# Certificate of Appropriateness (COA)

COA #: 151-17-CA

Property Address: 408 E Lane St

Change in design, moving the gate 6' back from the rest of the fence line across the driveway.

Change to driveway fence/gate design

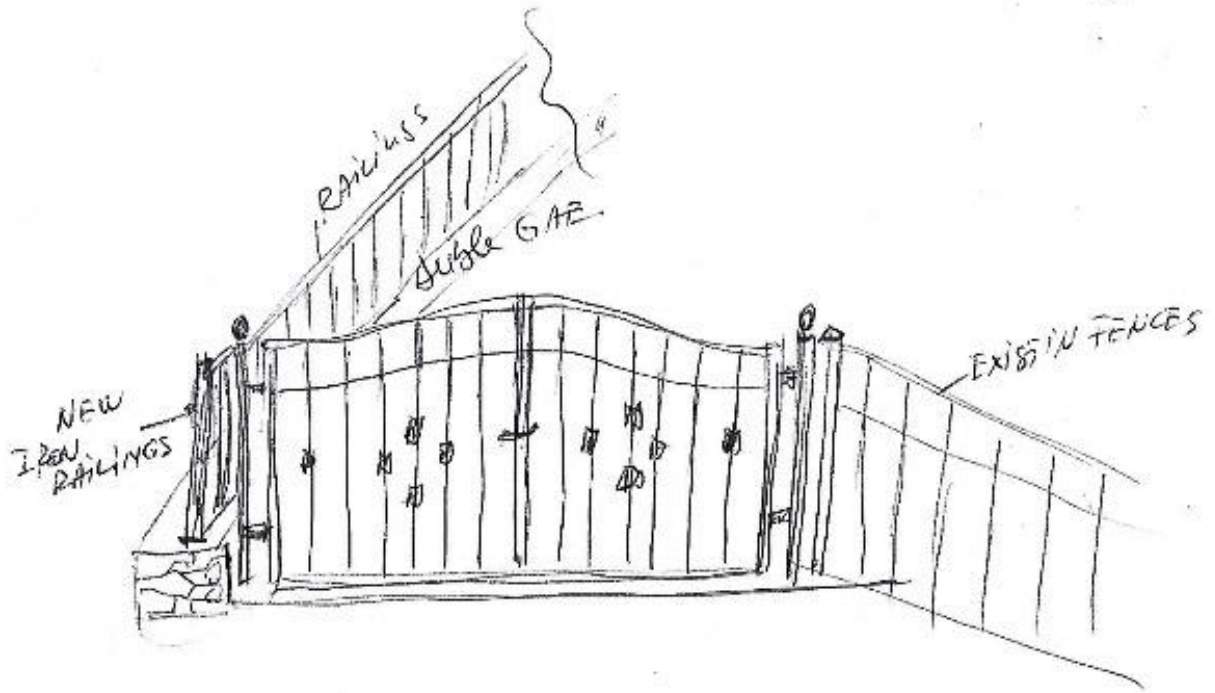
The approved plan shows the gate aligned with the existing fence at the sidewalk. We wish to make a small adjustment in the placement, moving the gate 6' into the driveway, to allow clearance for a car to pause to open the gate when entering.

The attached sketch from our wrought iron artisan shows how the gate matches both the existing fence and the new fence. The top rail of the gate will match the top rail of the existing 48" fence and that of the new 36" fence because the shorter new fence is elevated onto the existing retaining wall. The corner of the gate at the wall is mounted to a post at the driveway level, so the bottom rails will match up as well.

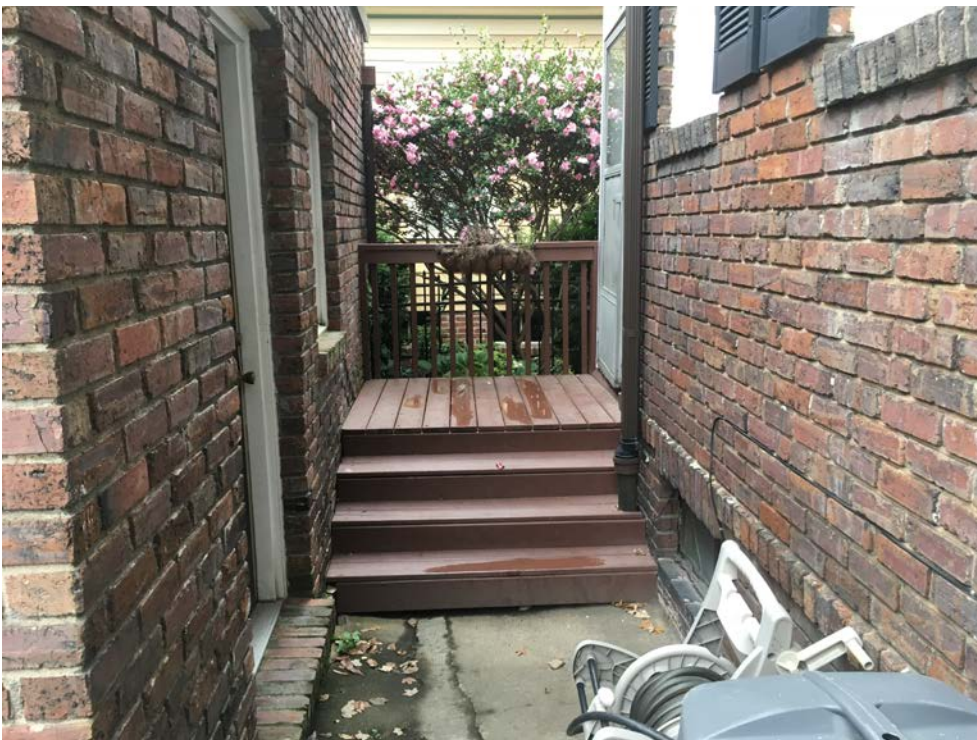
- 2\* The height of the existing fence is 50" at the south gatepost. It is unclear from the application if the 36" tall fence proposed for the top of the retaining wall will match the height of the adjacent fencing where these two items meet at the southeast corner of the lot.

- ✓ 1. That tree protection plans be implemented and remain in place for the duration of construction.
- ✓ 2. That details and specifications for the following be provided to and approved by staff prior to issuance of the blue placard:
  - a. Tree protection plan.
- 3. That details and specifications for the following be provided to and approved by staff prior to installation or construction:
  - a. Fence height detail where retaining wall fence and driveway fence extension meet;
